## *City of El Paso – City Plan Commission Staff Report*

**Case No:** SUSC13-00003 Colfax MCA Addition  
**Application Type:** Resubdivision Combination  
**CPC Hearing Date:** April 18, 2013  
**Staff Planner:** Raul Garcia, 915-541-4935, [garcia1@elpasotexas.gov](mailto:garcia1@elpasotexas.gov)  
**Location:** South of I-10 and East of Raynolds  
**Acreage:** 12.95 acres  
**Rep District:** 3  
**Existing Use:** Commercial  
**Existing Zoning:** SCZ (Smart Code)  
**Proposed Zoning:** SCZ (Smart Code)

## ATTACHMENT 3

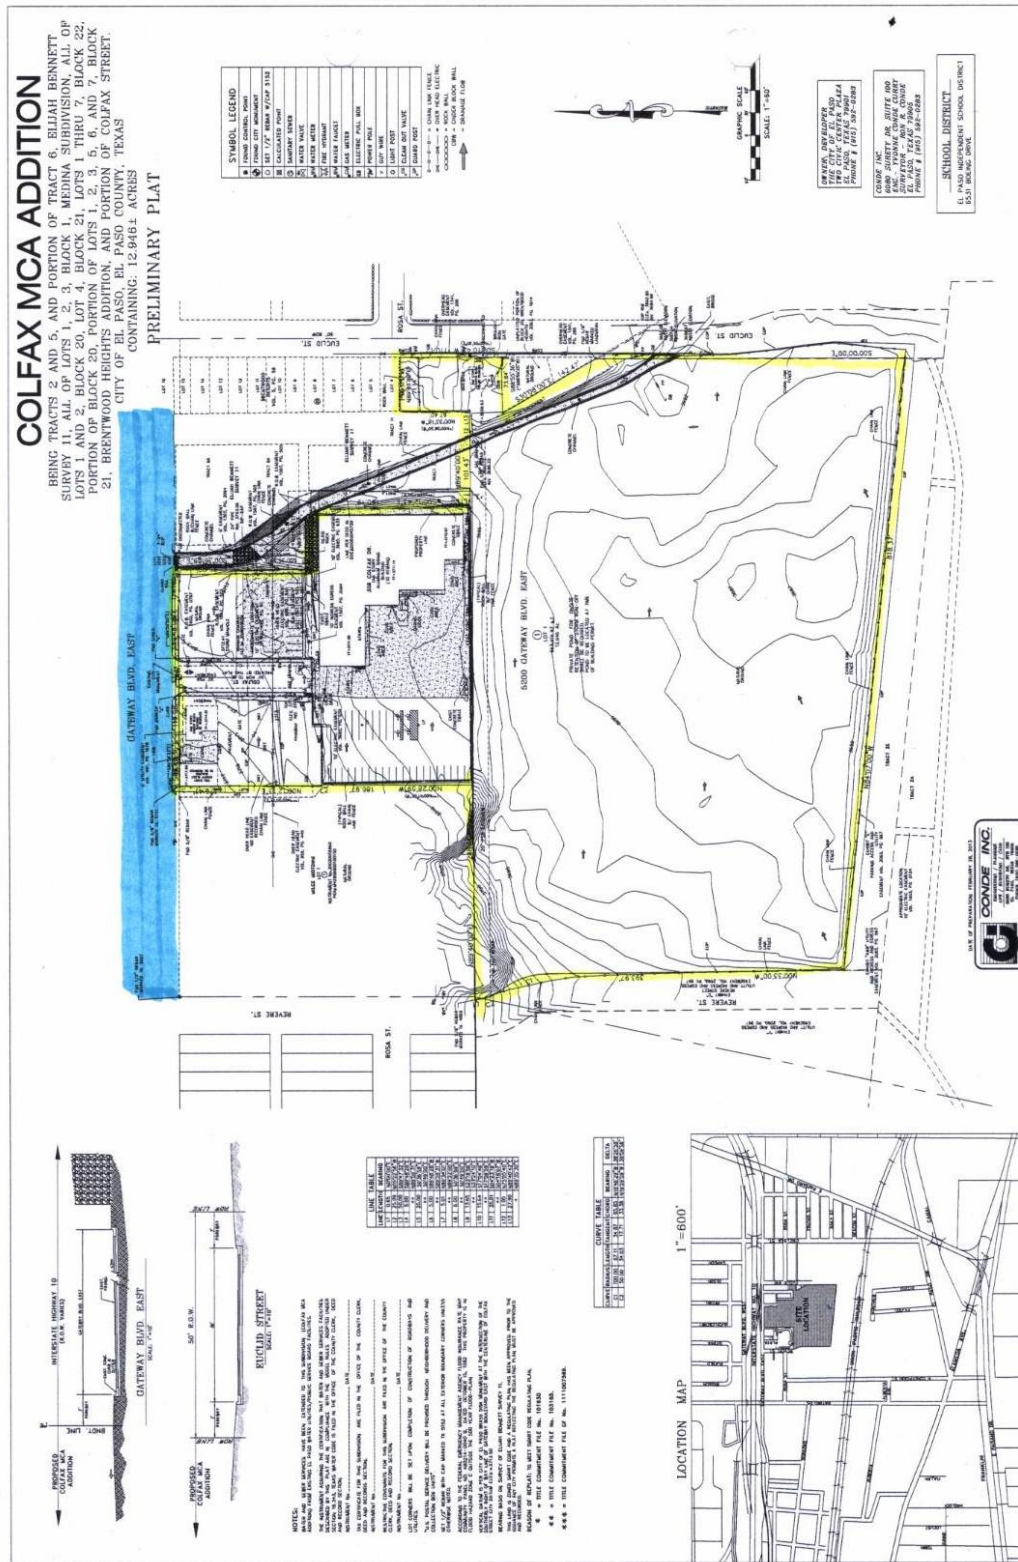
Approval subject to revision of the “reason for replat” note as the plat does not currently meet the smart code regulating plan.

This plat is currently designated an “interim” plat by inclusion of the note specified in Section 21.10.040.E. As an interim plat, if approved by the CPC, no City permits, to include grading permits may be pulled. If the intention is to pull permits of any kind following plat approval, then the note should be removed and prior to plat review by the CPC and the following will need to occur:

- a. The plat must be revised to reflect the Regulating Plan (see Section 21.10.040.D)
- b. A corresponding Preliminary Building Scale Plan must be submitted and approved (see Section 21.10.040.D).

1. The 30-foot wide PSB easement along Colfax Street is to include an anchor easement for the fire hydrant #8277 located at the southeast corner of the easement.
2. Improvements/upgrades to the existing water and sewer systems will be required to provide adequate service to the proposed site and adjacent properties as per the land uses described in the Medical Center of the Americas SmartCode Regulating Plan. Coordination with EPWU is required to construct the improvements in parallel with development.

3. There is an existing 8-inch diameter water main along Colfax Street. Also, there is an existing 4-inch diameter water main that extends west of Colfax Street thru the subject property along the vacated portion of Rosa Street. This water main needs to be cut & plugged and abandoned in place. This work is to be performed by EPWU-PSB Personnel at the cost of the Owner/Developer.

## ATTACHMENT 4

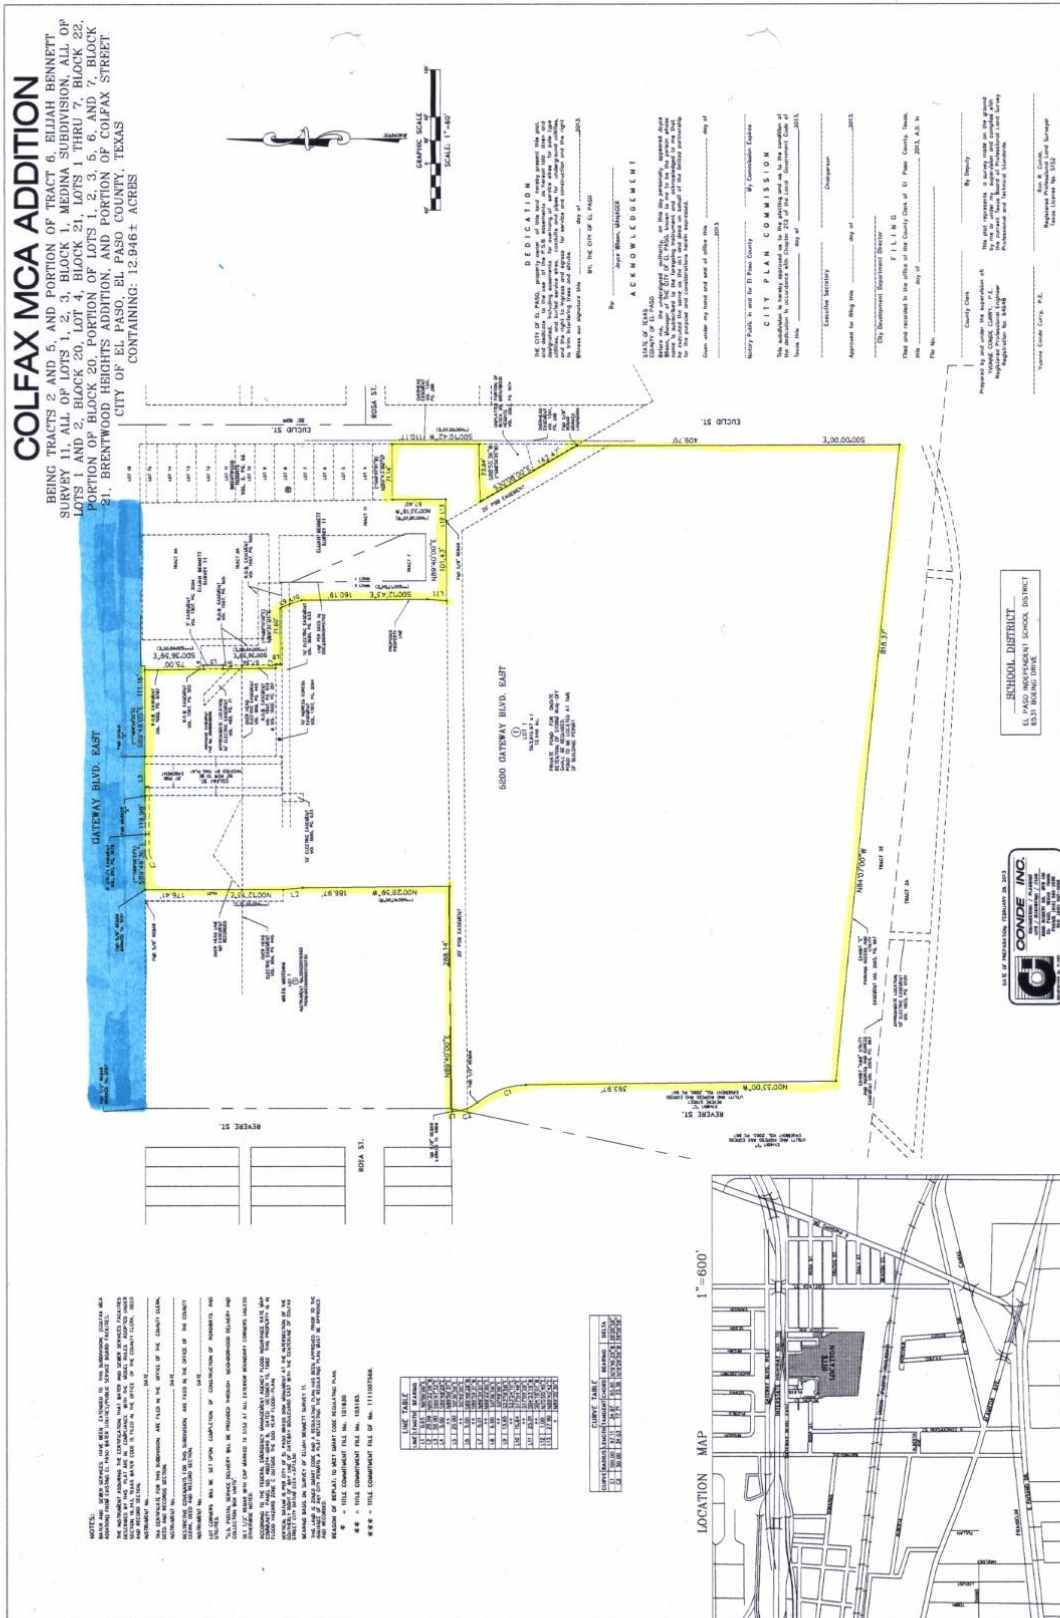
This plat is being reviewed under the SmartCode standards and, in accordance with Section 19.03.040.K of the subdivision code, is designated as an “Interim” plat. A plat reflecting the approved regulating plan shall be approved and recorded prior to the applicant pulling any city permits. A note has been placed on the final plat indicating such requirement.
